Form 3160-5
(June 2019)UNITED STATES
DEPARTMENT OF THE INTERIOR
BUREAU OF LAND MANAGEMENTFORM APPROVED
OMB No. 1004-0137
Expires: October 31, 2021**SUNDRY NOTICES AND REPORTS ON WELLS**
Do not use this form for proposals to drill or to re-enter an abandoned well. Use Form 3160-3 (APD) for such proposals.

8. Well Name and No. MODELO 10 FED COM/508H

EOG respectfully requests an amendment to our approved APD for this well to reflect the following changes:

Modelo 10 Fed Com 742H (FKA 508H) API #: 30-025-50939

WELL LOCATION AND ACREAGE DEDICATION PLAT

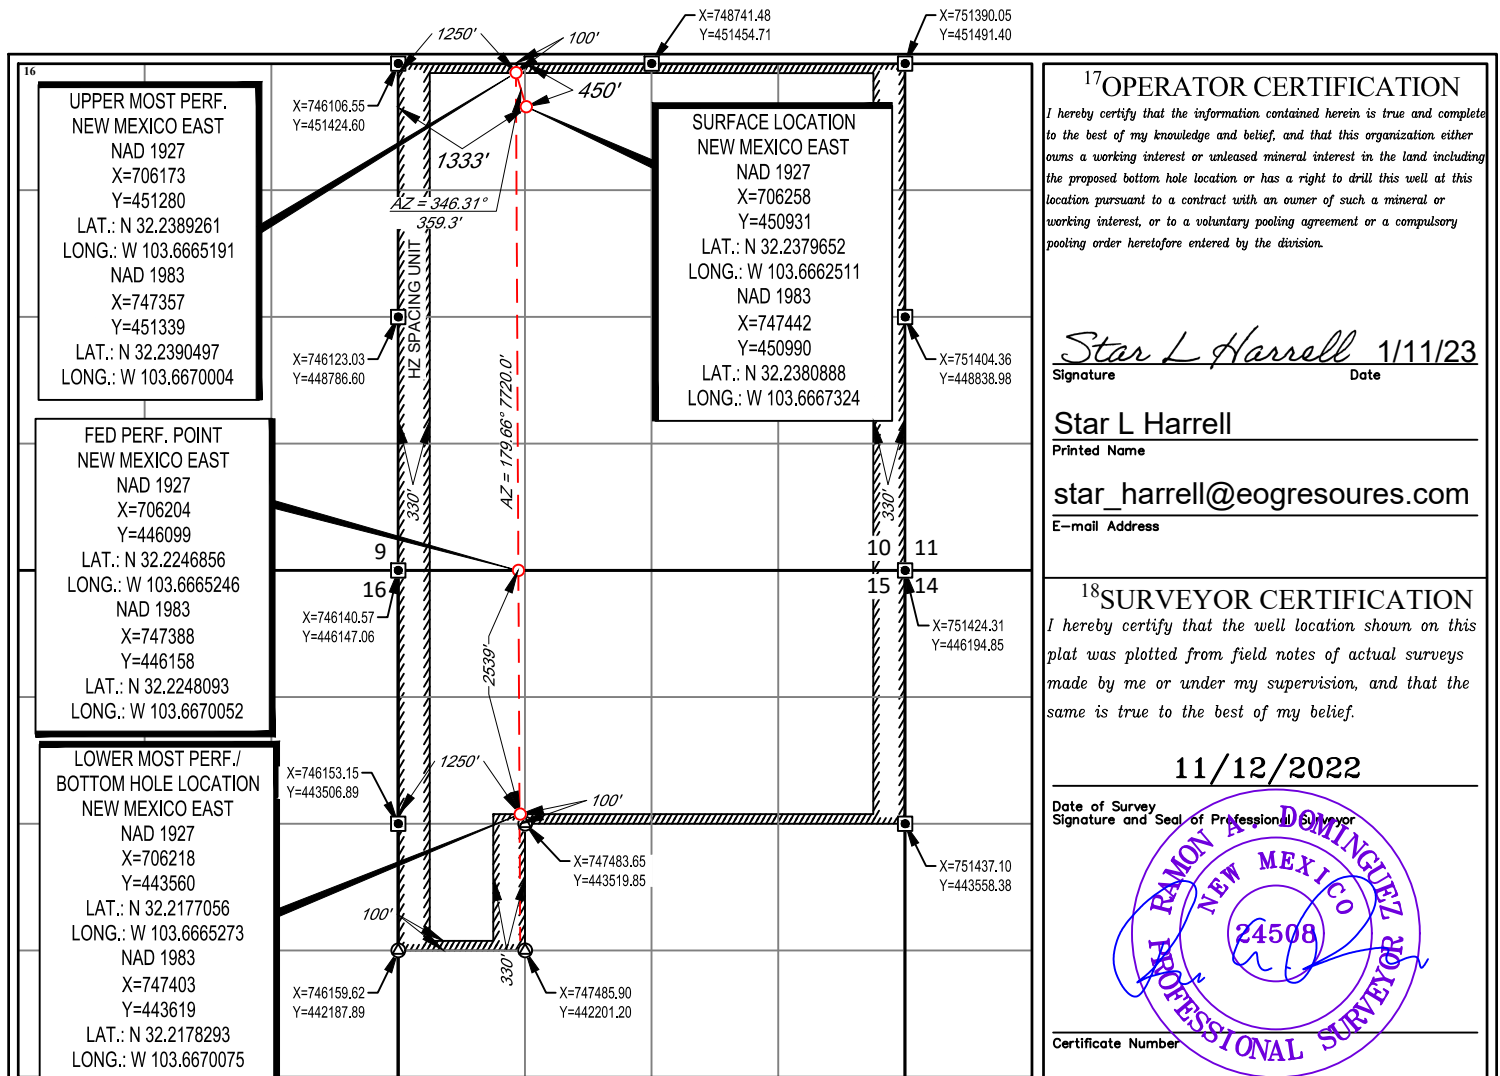
Change BHL from T-24-S, R-32-E, Sec 15, 2539' FNL, 1650' FWL, Lea Co., NM, to T-24-S, R-32-E, Sec 15, 2539' FNL, 1250' FWL, Lea Co., N.M.

UL or lot no.	Section	Township	Range	Lot Idn	Feet from the	North/South line	Feet from the	East/West line	County
E	15	24-S	32-E	-	2539'	NORTH	1250'	WEST	LEA
